East Wenatchee Water District	WATER SYSTEM STANDARD DETAIL
Water Service, Air Valve, Blow Off Vault Installation Details	
DRAWING NO. W-29 SHEET NO. 17

REVISION HISTORY

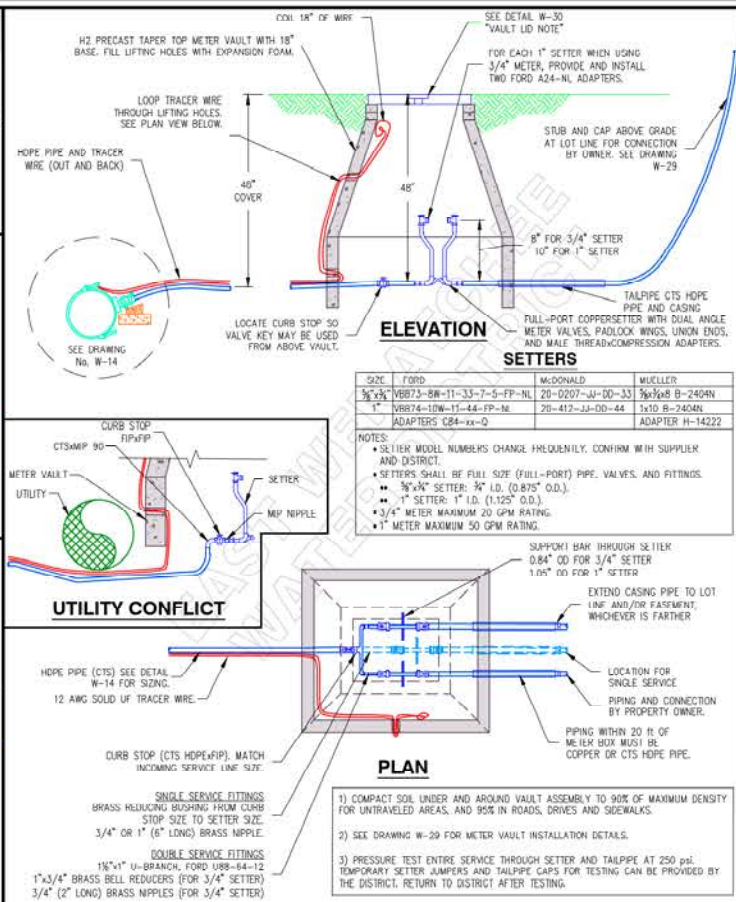
- W-26 REVISED LADDER-UP TO BE SPRING LOADED AND INCLUDED APPROVED MATERIALS FOR THE LADDER
- W-29 ADDED REFERENCE TO RETAINING WALL DETAIL TO GENERAL NOTE 4

- W-12 (NOTE 13) ADDED MAXIMUM GAUGE SCALE REQUIREMENT.
- W-29 CLARIFIED MAXIMUM 6" VERTICAL ADJUSTMENT.
- W-30 (NOTE 23) UPDATED LID/FRRM MODEL NUMBERS.
- W-30 (NOTE 29) ADDED NEW NOTE ABOUT DISTRICT LOANED EQUIPMENT.

- W-02, W-14, W-18, W-21, W-31 REVISED TRACER WIRE CONFIGURATION
- W-04 REVISED PRECAST BLOCK CALLOUT LISTING AVAILABLE SIZES.
- W-12 SIGMA BOX TOPS NO LONGER ALLOWED DUE TO CLEARANCE ISSUES.
- W-12 REMOVED TRACER WIRE FROM VALVE BOX.
- W-12 ADDED VALVE BOX COLLAR.
- W-18 UPDATED METER SETTER MODEL NUMBERS.
- W-23 CHANGED HILLHOLDER WALLS FROM ROCKS TO PRECAST BLOCK.
- W-26 ADDED GAS SHOCK OPTION FOR HATCH.
- W-29 NOW GRAPHICALLY SHOWS LID ADJUSTMENT RISERS.

East Wenatchee Water District	WATER SYSTEM STANDARD DETAIL
3/4" AND 1" SINGLE AND DOUBLE WATER SERVICES	
DRAWING NO. W-21 SHEET NO. 18

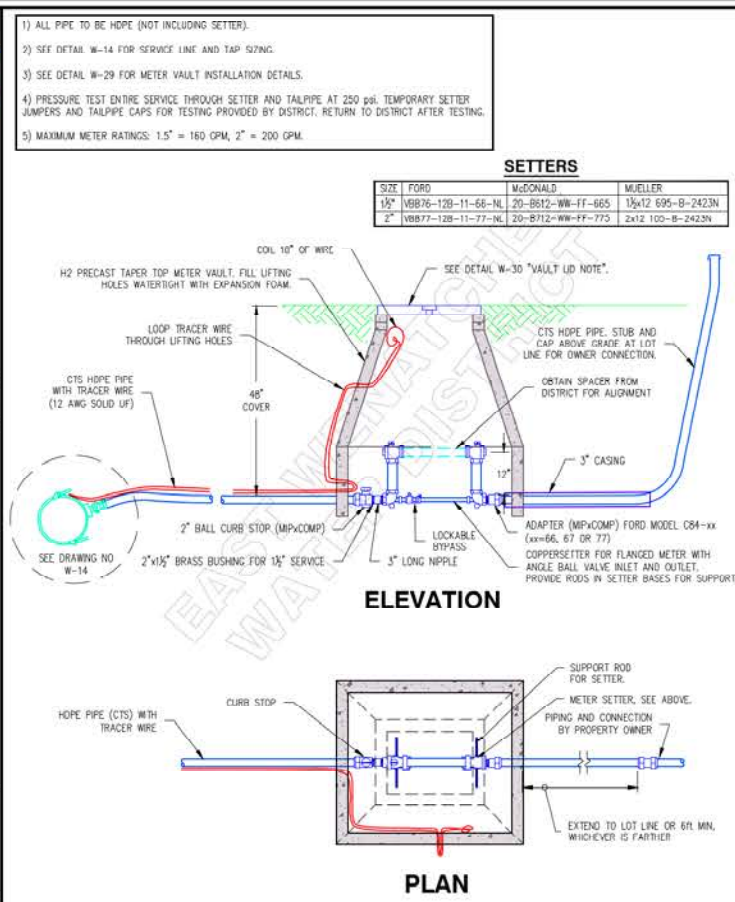
- W-20 REMOVED EXTERIOR BLOCKS AND SHACKLES, ADDED NOTE 8, UPDATED FITTING NO. 2 FROM MJ TO RJ
- W-21 REMOVED NOTE 4 REGARDING MASTIC BETWEEN CHAMBER TOP AND BASE

- W-21 ADDED NOTE REGARDING PRESSURE TESTING SERVICE
- W-21 ADDED NOTE IN ELEVATION REGARDING REQUIRED ADAPTER IN 1" SETTERS
- W-24 REMOVED EXTERIOR BLOCKS AND SHACKLES, ADDED NOTE 8, UPDATED FITTING NO. 2 FROM MJ TO RJ WITH NO FCA OPTION

- W-20 ADDED A VALVE AND DRAIN ON THE BYPASS
- W-21 REVISED TRACER WIRE TO NOT WRAP AROUND PIPE
- W-21 UPDATED THE MUELLER MODEL NUMBER
- W-22 REMOVED NOTES AND PIPING THAT WAS REDUNDANT TO DETAIL W-15

East Wenatchee Water District	WATER SYSTEM STANDARD DETAIL
LARGE VAULTS	
DRAWING NO. W-26 SHEET NO. 20

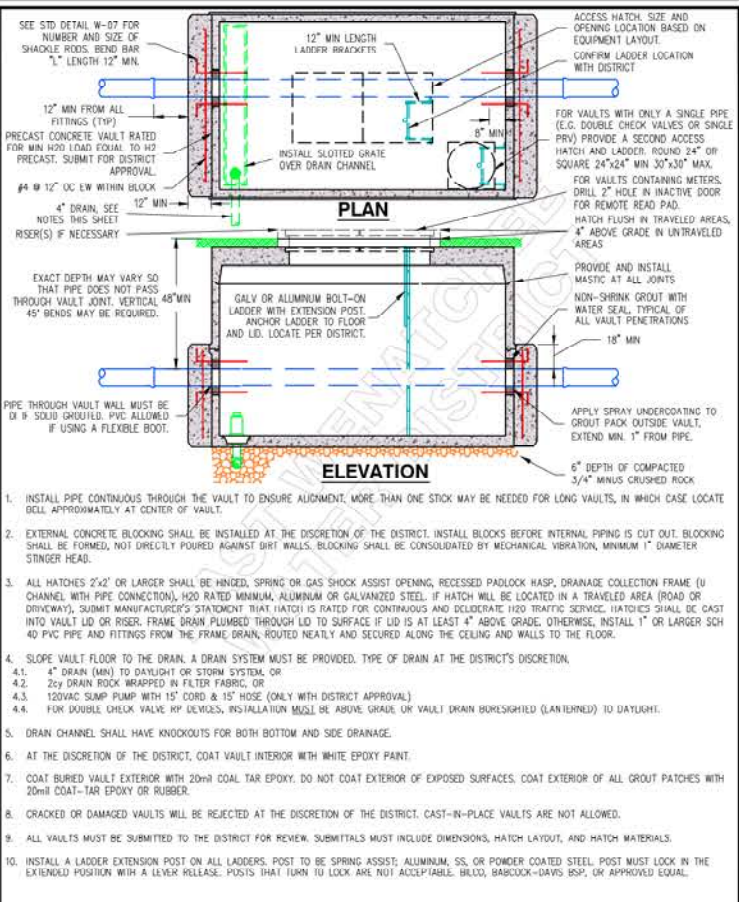
- W-26 REMOVED ALL WALL COLLARS
- W-26 UPDATED NOTE 2 TO HAVE THE DISTRICT DECIDE IF EXTERNAL BLOCKS ARE REQUIRED
- W-26 CLARIFIED IN NOTE 3 TO NEATLY ROUTE DRAIN PIPING IN VAULT

- W-26 CREATED A NEW NOTE 7 ALLOWING THE DISTRICT TO REQUIRE INTERIOR PAINT
- W-26 UPDATED NOTE 8 (WAS PREVIOUSLY 7) TO REQUIRE EXTERIOR COAT OR GROUT PATCHES

- W-24 ADDED A VALVE AND DRAIN ON THE BYPASS
- W-26 CLARIFIED NOTE ABOUT DRILLING 2" HOLE IN DOOR, ONLY IF VAULT HAS METER
- W-26 ADDED NOTE ABOUT A SPRAY UNDERCOAT TO THE GROUT PACK

- W-26, CLARIFIED LADDER EXTENSION POST PRODUCT REQUIREMENTS.
- W-30, BROKE OUT MATERIAL SPECS INTO SEPARATE LIST CLARIFIED VALVES TO BE RISING STEM

East Wenatchee Water District	WATER SYSTEM STANDARD DETAIL
3" METER ASSEMBLY	
DRAWING NO. W-20 SHEET NO. 21

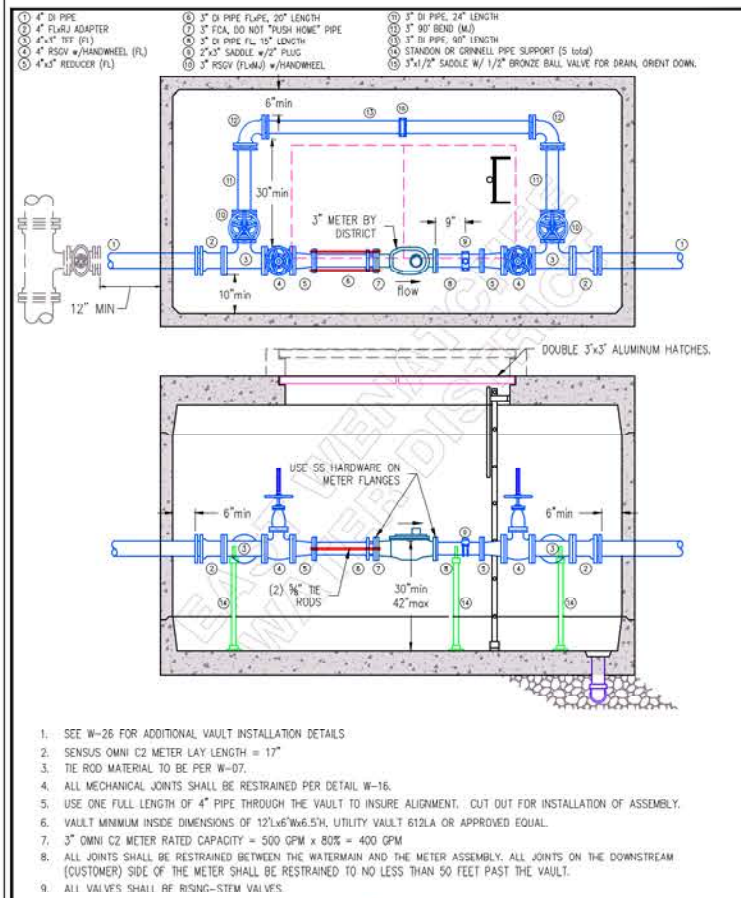
- W-20, CLARIFIED VALVES TO BE RISING STEM.
- W-22, ADDED ROMAC 501 TO APPROVED COUPLINGS.
- W-25, ADDED ISOLATION VALVE BETWEEN THE METER AND BACKFLOW ASSEMBLY AND THAT THE DEVICE WILL BE IN A HOT BOX UNLESS OTHERWISE APPROVED BY THE DISTRICT.

East Wenatchee Water District	WATER SYSTEM STANDARD DETAIL
PRESSURE REDUCING STATION	
DRAWING NO. W-19 SHEET NO. 23

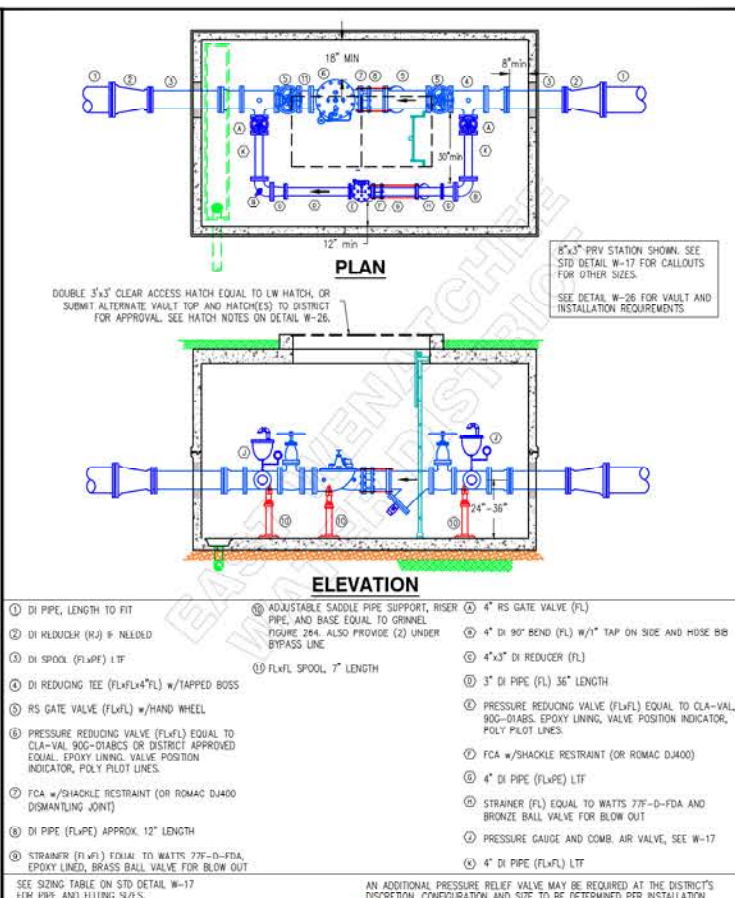
- W-13 INCLUDED IPERL IN TYPE OF METER ALLOWED
- W-15 INCLUDED AIR VALVE ASSEMBLIES IN WATER SERVICE SECTION TITLE
- W-19 REMOVED WALL COLLARS FROM DETAIL

- W-19 ADDED FLWRJ ADAPTERS TO EACH END OF THE MAIN PIPE IN THE VAULT
- W-19 ADDED A SPOOL OF PIPE TO SEPARATE THE PRIV'S AND MOVE THE LADDER
- W-19 REVISED ITEM NO. 4, REDUCING TEE, TO COME WITH A TAPPED BOSS

East Wenatchee Water District	WATER SYSTEM STANDARD DETAIL
PRESSURE REDUCING STATION	
DRAWING NO. W-17 SHEET NO. 24

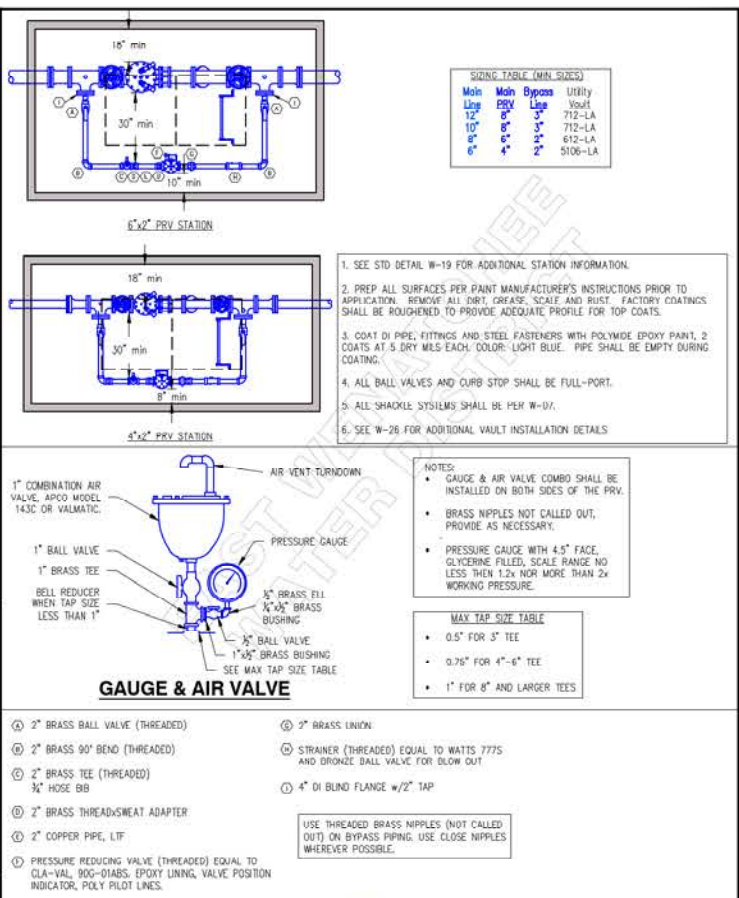
- W-16 UPDATED THE REQUIRED RESTRAINED LENGTHS FOR ALL FITTINGS
- W-17 ADDED A BELL REDUCER ON THE GAUGE & AIR VALVE DETAIL
- W-17 ADDED A MAX TAP SIZE TABLE

WATER SYSTEM STANDARD DETAIL
BACKFLOW PREVENTION ASSEMBLY

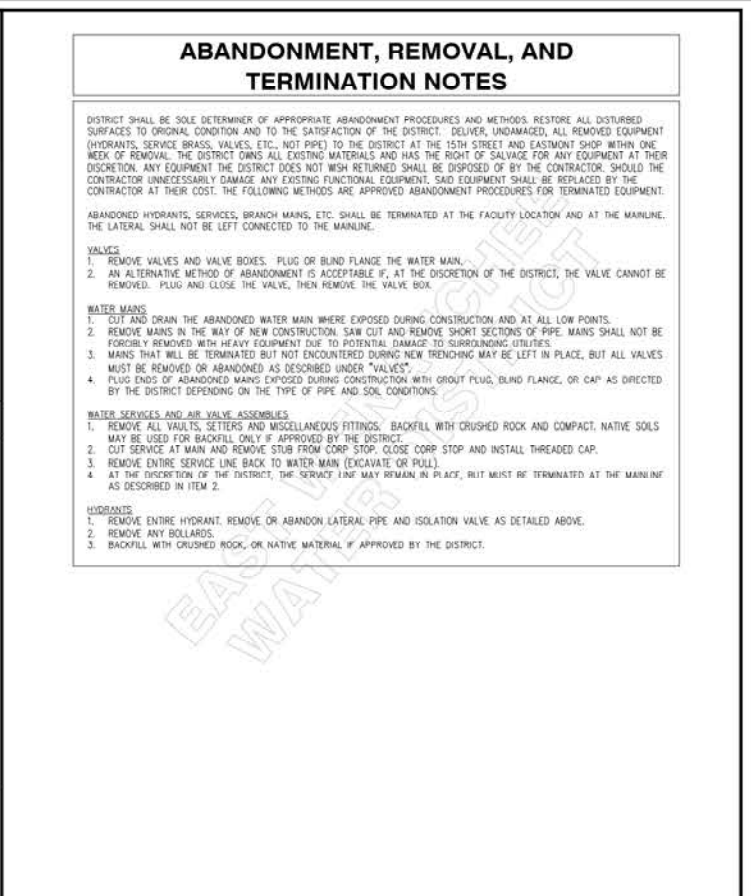
- W-13 REVISED MINIMUM VAULT SIZE REQUIREMENTS
- W-13 REVISED SADDLE FIT RANGE
- W-18 ADDED MUELLER PRODUCT INFORMATION TO TABLE
- W-21 ADDED MUELLER PRODUCT INFORMATION TO TABLE
- W-30 ADDITIONAL SPACING REQUIREMENTS FOR CASING RUNNERS

- W-10 CLARIFIED MATERIAL ALLOWED FOR CORP STOP BLOCKING
- W-12 ADDED NOTE 8 AND ADDED PLAN VIEW OF BOX LID
- W-13 UPDATED NOTE 3 TO CLARIFY RESTRAINED PIPE REQUIREMENTS

- W-13 REMOVED THRUST BLOCKS AND SHACKLES
- W-13 CHANGED THE FCA TO A FLWRJ ADAPTER
- W-13 UPDATED VAULT MIN INTERIOR DIMENSION REQUIREMENTS TO MATCH NEW PIPE LAYOUT

- W-13 ADDED 12" VALVE SIZE DATA TO THE VAULT MIN. INSIDE TABLE
- W-14 ADDED 1" MIN SIZE TO PE SERVICE PIPE
- W-14 REVISED TRACER WIRE TO NOT WRAP AROUND PIPE

- W-01 (NOTE 1) ADDED TO USE MOST CURRENT VERSION OF STANDARDS.
- W-01 (NOTE 1.5) ADDED TO PRELUST VALVES PRIOR TO INSTALLATION.
- W-13 ADDED MAXIMUM DRAIN PIPE LENGTH OF 20 FEET.
- W-16 ADDED MULTIPLIER FOR PVC PIPE. ADDED THAT SET-SCREW RESTRAINTS NOT ALLOWED. ADDED TYLER TUFGRIP RESTRAINTS ARE NOT ALLOWED (DUE TO QUALITY CONTROL ISSUES).
- W-25 ADDED MAXIMUM DRAIN PIPE LENGTH OF 20 FEET.
- W-30 (NOTE 23) ADDED COEFFICIENT OF FRICTION REQUIREMENT.
- W-31 REMOVED TRACER WIRE IN VALVE BOXES.

- W-01 ADDED THAT PRESSURE WASHERS NOT ALLOWED FOR PRESSURE TESTING.
- W-03 CHANGED PAVEMENT PATCH MATERIAL FROM CLASS B TO HMA CL 3/8". ADDED PIPE ALIGNMENT TOLERANCES.
- W-13 REVISED VAULT LENGTH CRITERIA.

- W-13, ADDED VALVES TO BE RISING-STEM FOR FIRE LINES; ALTERNATIVE HATCH LAYOUT TO BE APPROVED BY THE DISTRICT; AND THE BYPASS METER IS TO BE PROVIDED BY THE DISTRICT.

WATER SYSTEM STANDARD DETAIL
BACKFLOW ASSEMBLY INSTALLATION

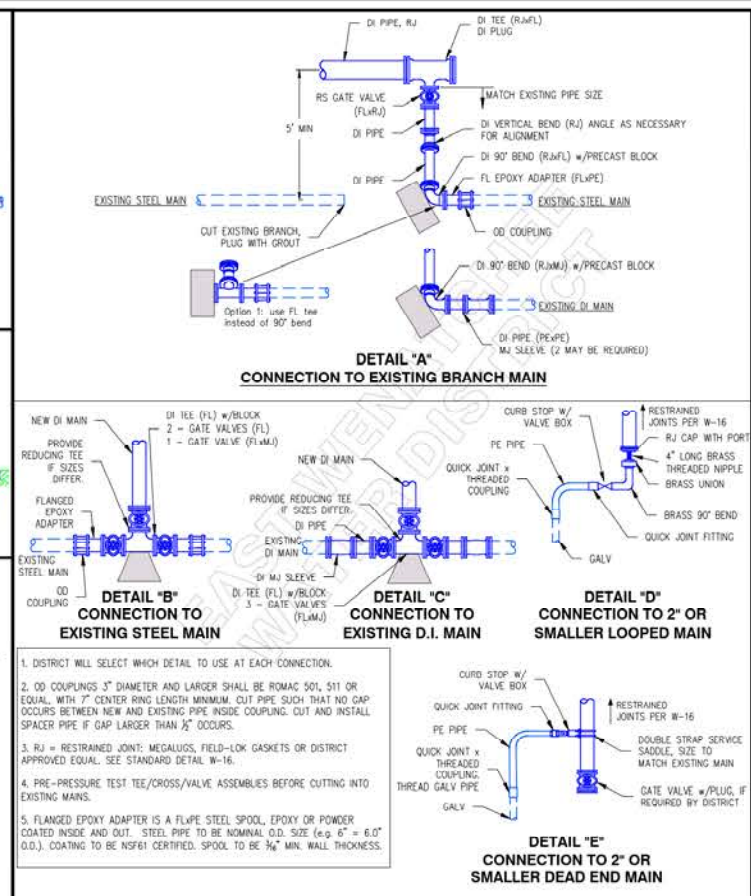
- W-14 SADDLES, CORP STOPS, AND SERVICE LINES FOR ALL 3/4" AND 1" SINGLE AND DOUBLE METERS ARE NOW 1.5" DIAMETER
- W-25 DISTRICT MAY ALLOW LATERAL PIPE VELOCITY UP TO 10 FPS WITH CL52 DI.

WATER SYSTEM STANDARD DETAIL
CONNECTIONS TO EXISTING MAINS

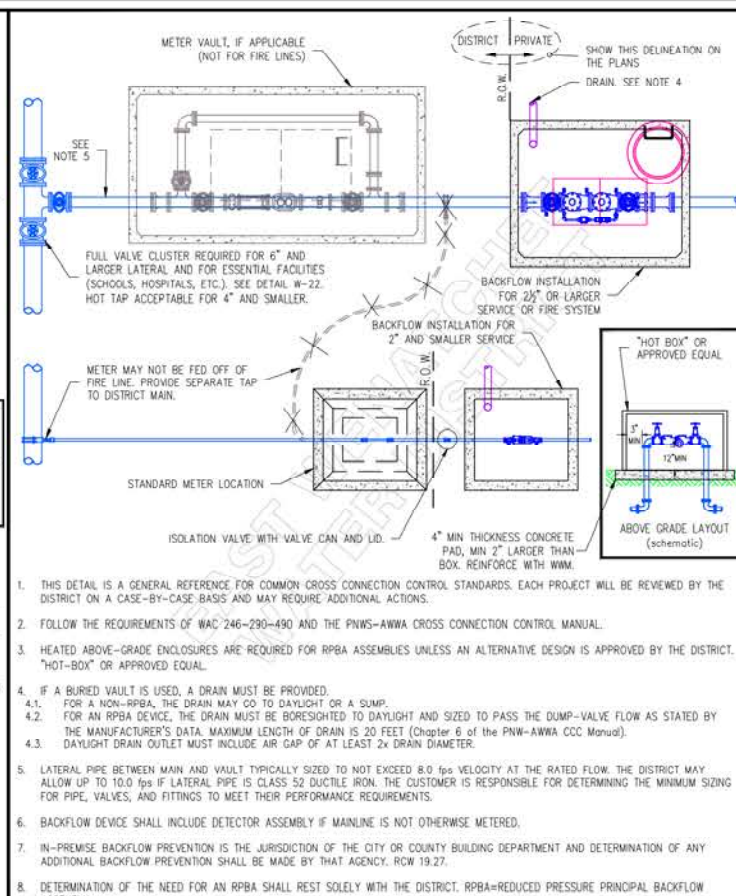
- W-22 UPDATED GENERAL NOTE 1 TO READ WATERMAIN INSTEAD OF BRANCH
- W-22 UPDATED COUPLING NOTE TO INCLUDE ROMAC 511 COUPLING OR EQUAL WITH A 7" CENTER RING LENGTH MINIMUM.

WATER SYSTEM STANDARD DETAIL
TRACER WIRE

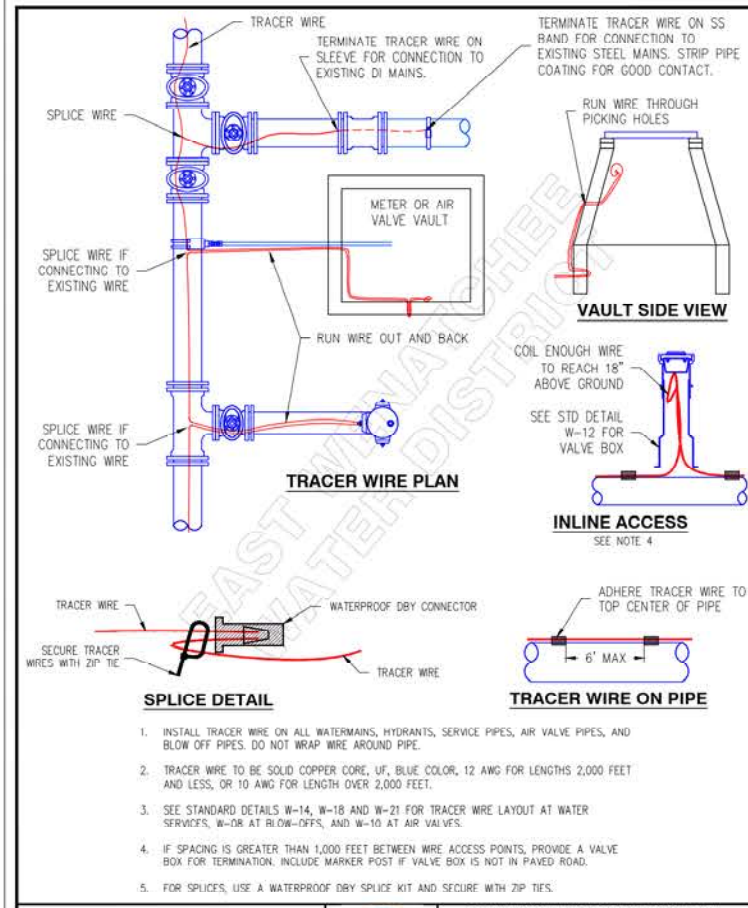
- W-31 NEW DETAIL CREATED FOR TRACER WIRE INSTALLATION
- W-32 NEW DETAIL CREATED FOR CASING PIPES

- W-30 UPDATED THE DIMENSIONS FOR THE RECESSED HOLE FOR THE RADIO.
- W-30 ADDED NOTE STATING THE TYPE OF VALVES TO BE USED WHEN SMALLER THAN 4"
- W-31 UPDATED TRACER WIRE TO COME IN BETWEEN TWO PARTS OF VALVE BOX

- W-31 UPDATED DETAIL TO SHOW TRACER WIRE TERMINATING ON SLEEVE OR COUPLING
- W-31 REVISED THE WATERPROOF NUT TO A WATERPROOF DRY CONNECTOR
- W-31 REMOVED TRACER WIRE WRAPPING DETAIL

- W-31 ADDED GENERAL NOTE 6
- W-32 ADDED DETAIL FOR CASINGS LONGER THAN 20'
- W-32 INCLUDED A CROSS SECTION OF THE CROSS UTILITY FOR EACH CASING DETAIL.
- W-32 ADDED NOTE ABOUT CASING RUNNER SELECTION SIZE.

- W-01 REVISED NOTE 11 THAT RESTRAINED JOINTS ARE NOW GENERALLY ALLOWED INSTEAD OF THRUST BLOCKS.
- W-02 4" STORZ ADAPTER NOW REQUIRED FOR ALL HYDRANTS.
- W-04 REVISED TABLES SO SAND AND SANDY SILT ARE THE DEFAULT MATERIAL (1.0 MULTIPLIER).
- W-08 CHANGED SWING JOINT FROM STEEL TO BRASS.
- W-11 ADDED MULTIPLE AND 4" BLOW OFF CONFIGURATION OPTIONS
- W-12 INCREASED INLINE VALVE RESTRAINED JOINT LENGTH REQUIREMENT (NOTE 5).
- W-13 REVISED VAULT SIZES
- W-16 ADDED LENGTHS FOR COMBINED BENDS.
- W-29 ADDED REQUIREMENT TO INSTALL SIDEWALK PANEL AROUND LID WHEN SIDEWALKS ARE DEFERRED.
- W-31 ADDED ACCESS BOX DETAIL.
